**TOWN OF LEESBURG, VIRGINIA
DEPARTMENT OF CAPITAL PROJECTS MANAGEMENT
25 WEST MARKET STREET
LEESBURG, VIRGINIA 20176**

**LOWER SYCOLIN SEWAGE CONVEYANCE SYSTEM
IFB No. 07404-FY12-01**

**ADDENDUM NO. 2
November 22, 2011**

SYCOLIN PUMP STATION
SKETCH E-2 SK1

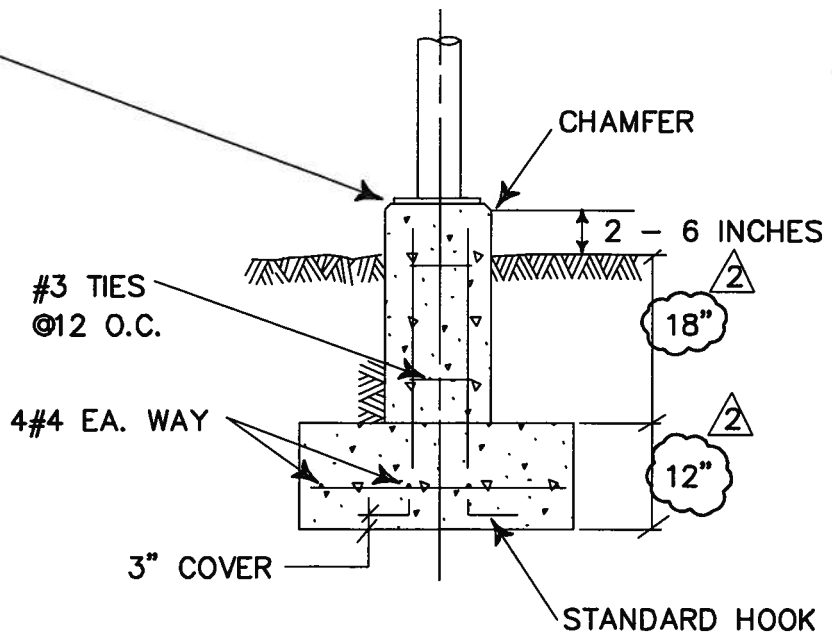
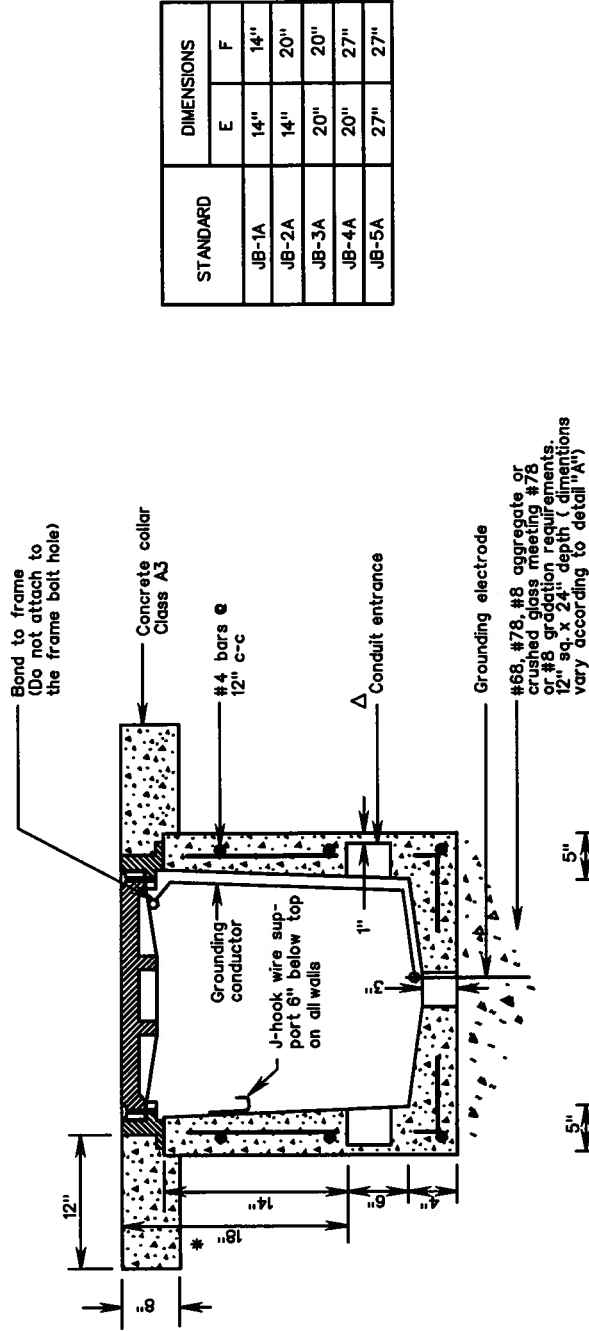
12. Q. Drawing E-2. Pole Base Detail for spread footer option does not indicate depth requirements, please clarify.
- A. To Drawing E-2 ADD attached sketch E2 SK 1 (**Attachment No. 1**). The missing dimensions have been added.

POLE INSTALLATION & ANCHOR BOLTS TO FIXTURE SUPPLIER'S RECOMMENDATIONS

JUNCTION BOX

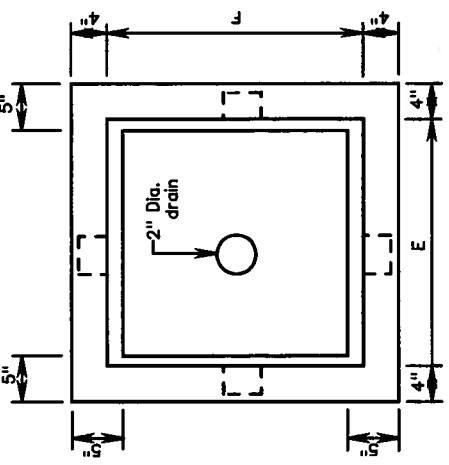
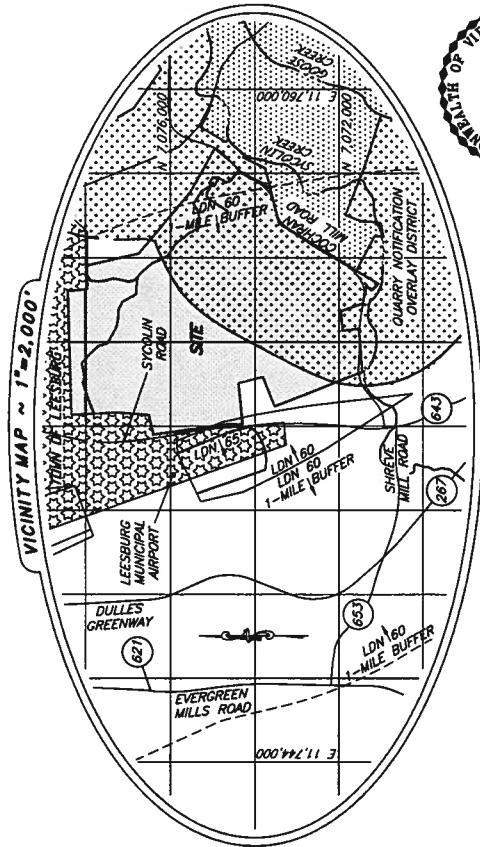
- 19 Q. Specification 16050. 3.2.A.4 and 3.2.C. Is there a specific requirement of the type of Pull Box required for these conduit runs where it may be required?

- A. ADD the following note to Sheet E-1.
NOTE: PULL BOXES IN NON-TRAFFIC AREAS OF GRADE SHALL BE POLYMER CONCRETE RATED FOR TIER 15 LOADING. PULL BOXES IN TRAFFIC AREAS SHALL BE VDOT STYLE JB (**Attachment No. 2**). PULL BOXES IN STRUCTURAL CONCRETE SHALL BE AN OUTSIDE FLANGED RECESSED COVER GALVANIZED CAST IRON BOX EQUAL TO OZ GEDNEY TYPE YR.

DETAIL AT PUMP
STATION SHOWING
TRANSFORMER
SUPPORT

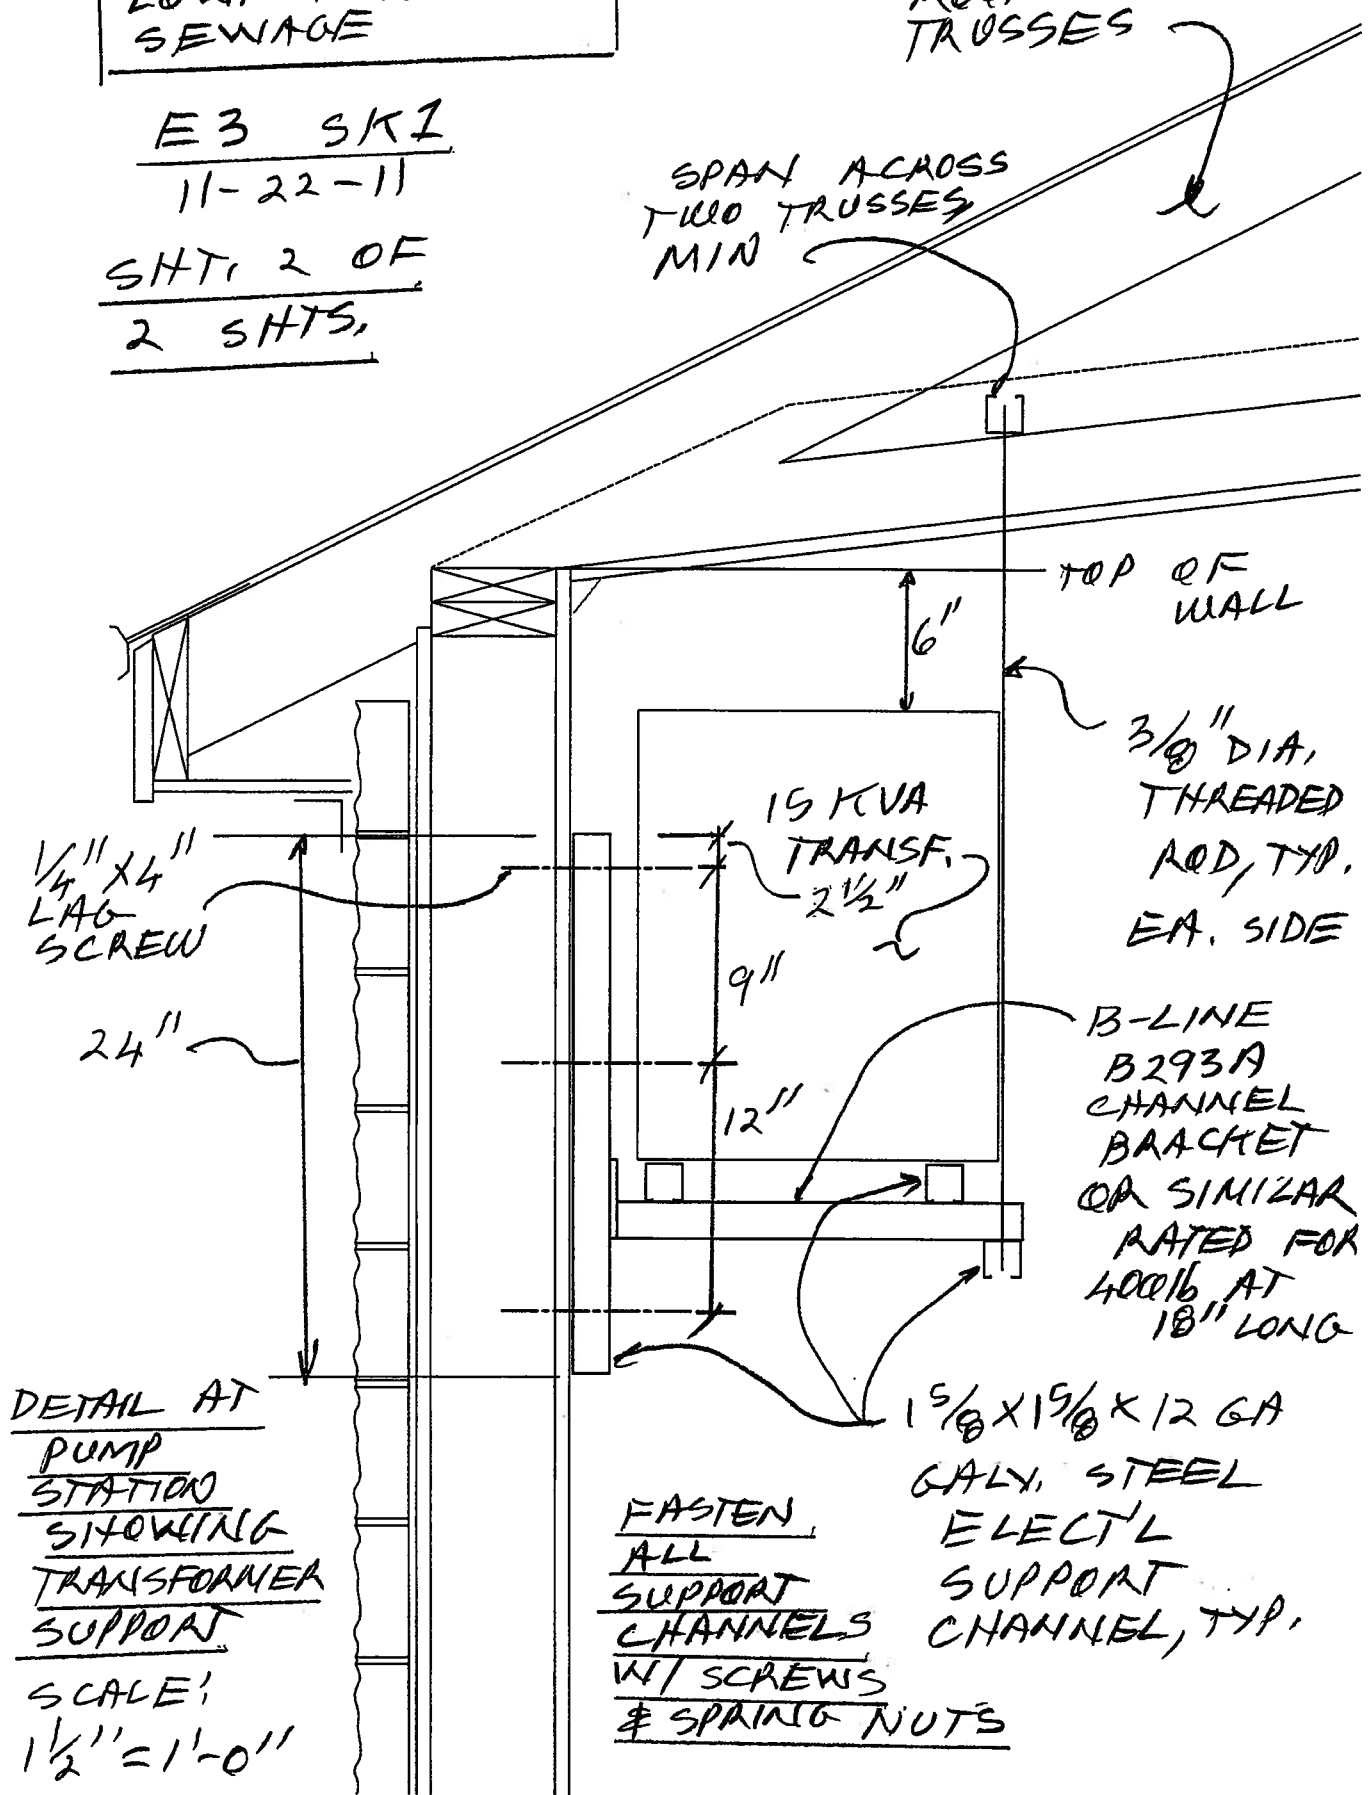
35. Q. We need engineered drawings on how the transformer is to be supported.

A. See attached sketch E3 SK1 (**Attachment No. 4**).
